Authorized Field Change

AFC 22901

Subject: Rear Axle Brake Chambers

Model: IC Bus[®] CE and RE Series school and commercial buses

Figure 1. Incorrect Mounting Position

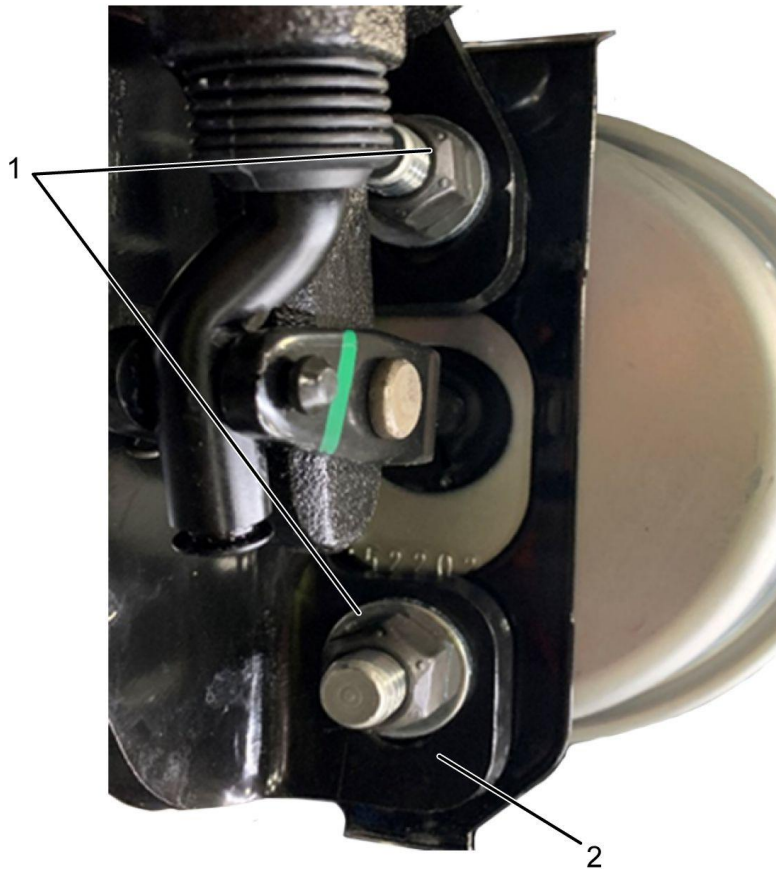
The rear axle brake chambers may be installed in the incorrect mounting slot which could lead to long term durability issues.

- a. If both spring brake chamber assemblies are mounted in correct mounting position (upper slot) (Figure 2, Item 2), go to Step 17.
 - b. If one or both spring brake chamber assemblies are mounted in incorrect mounting position (lower slot) (Figure 1, Item 2), go to Step 6.

6. Remove caging bolt from its holder and fully cage spring brake chamber assembly that needs to be moved.
 7. Remove clevis pin retaining clips (Figure 1, Item 3) and then remove clevis pins (Figure 1, Item 1) from slack adjuster. Save all for reuse.
